STORMWATER MANAGEMENT PLAN
FOR
Chick-Fil-A #05934
Powers & Palmer Park FSU
A Portion of Lot 1, Block 1, Waldorf Subdivision
COLORADO SPRINGS, COLORADO

January 2025

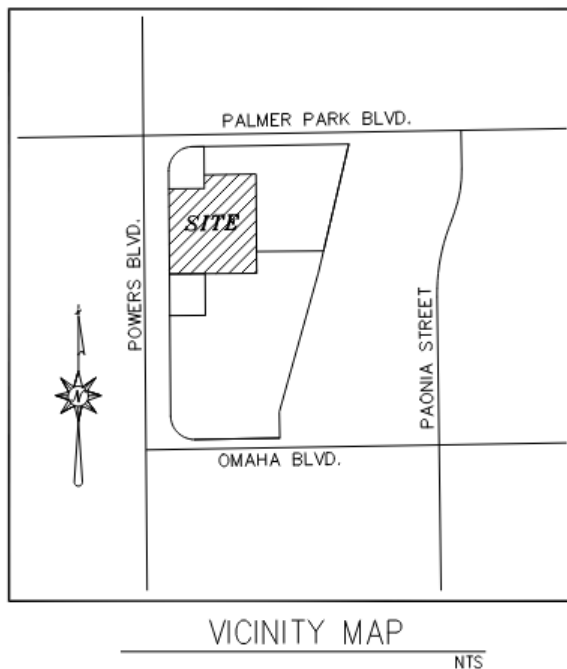
SWMP Checklist item B, C, and F. Include the signed ESQCP form (add a placeholder if the form is not signed yet) and the self-inspection form.

ESQCP Form added in Appendix G
